OG-10-246

Subject: PWR Owners Group
Transmittal of PWROG Comments on the NRC "Proposed Rule Changes to 10 CFR 50, Relating to Code Case N-770 and Nonmandatory Appendix E, Evaluation of Unanticipated Operating Events", Docket ID NRC-2008-0554, PA-MS-0483

Response to NRC Conditions on Code Case N-770

Response to NRC Comments Concerning ASME B&PV Code, Section XI, Nonmandatory Appendix E, "Evaluation of Unanticipated Operating Events."

Figure 1: Comparison of the Limit in Appendix E, Paragraph E-1200 with the $CPF = 1E-6$ Pressure versus Temperature Line for PWR Unanticipated Isothermal Pressure Events.

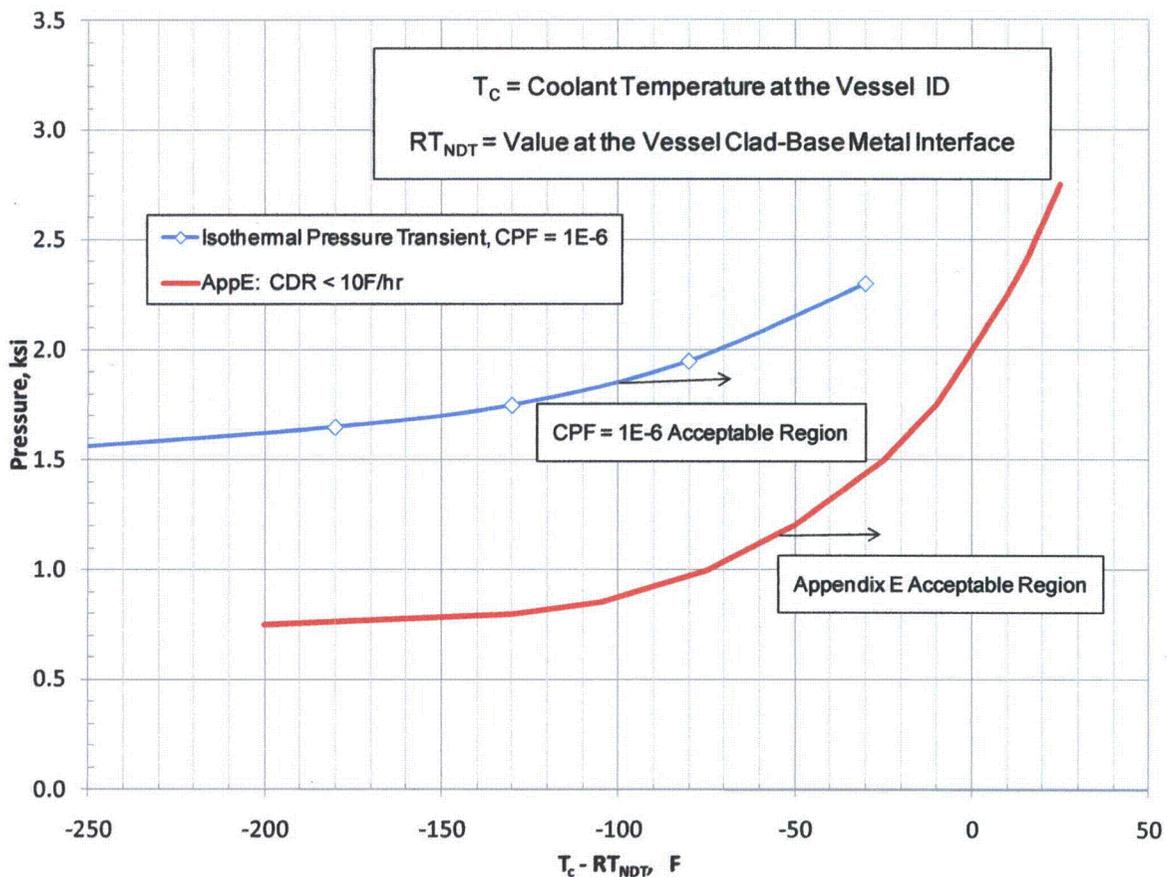
The results in the Figure 1 show that risk-informed curve corresponding to $CPF = 1E-6$ lies to the left of the limit curve from Appendix E, Paragraph E-1200 for isothermal pressure transients. This result demonstrates that Appendix E is consistent with risk-informed evaluation criteria, corresponds to a CPF of less than $1E-6$ and provides an effective and conservative methodology to screen out unanticipated isothermal pressure transients that may contribute to RPV failure.

The results presented in Figure 1 and Figure 2 show that the current criteria in Appendix E:

Consequently, modifying Appendix E as suggested by the NRC is unnecessary and disallowing use of paragraph E-1200 of Appendix E will result in an undue hardship without any compensating increase in safety.

Figure 2: Comparison of the Limit in Appendix E, Paragraph E-1200 with the CPF = 1E-6 Pressure Versus Temperature Lines for PWR Unanticipated Pressurized Cool-down Events.

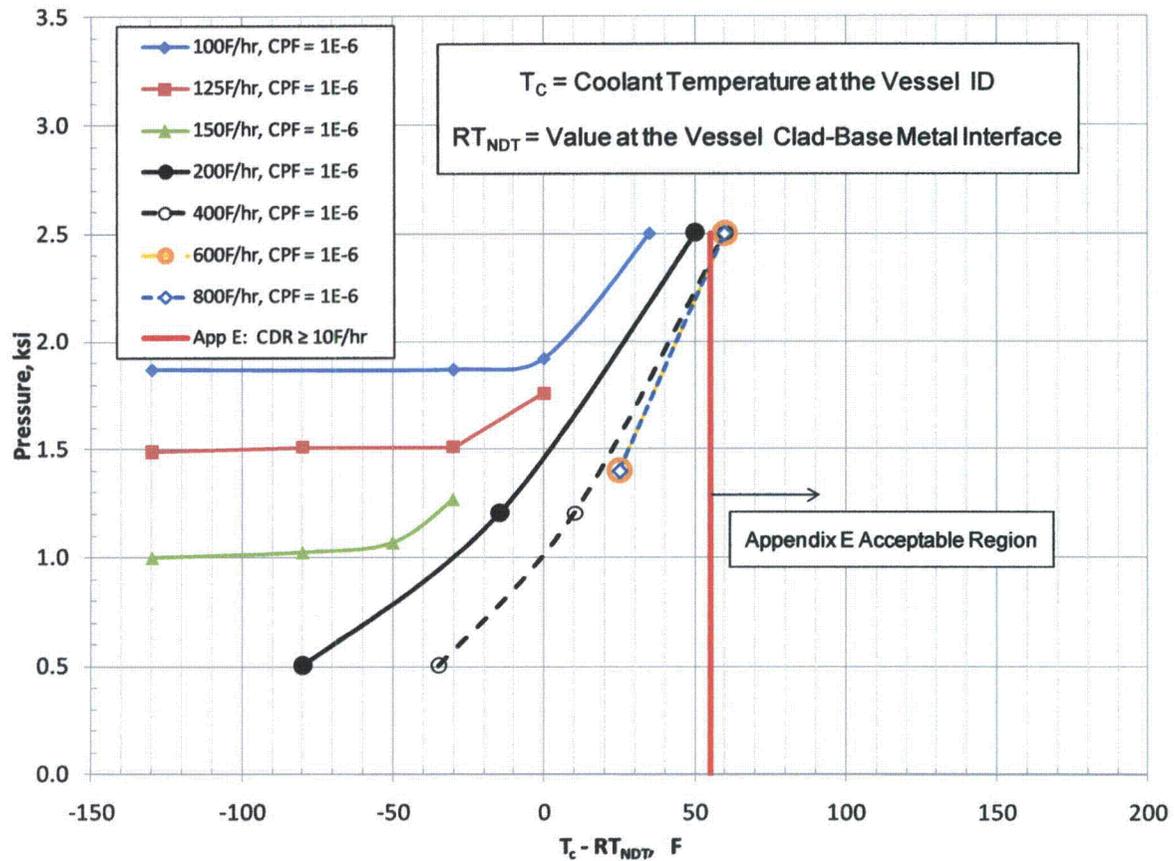
The results in the Figure 2 for pressurized thermal transients show that risk-informed curve corresponding to $CPF = 1E-6$ is essentially coincident with the Appendix E criteria at pressures above 2,400 psi and cool-down rates greater than $400^{\circ}F/hr$ and lies to the left of the limit curve from Appendix E, Paragraph E-1200 for pressures less than 2,400 psi and cool-down rates less than $400^{\circ}F$. This result demonstrates that Appendix E is consistent with risk-informed evaluation criteria, corresponds to a CPF of less than $1E-6$ and provides an effective and conservative methodology to screen out unanticipated pressurized thermal transients that may contribute to RPV failure.
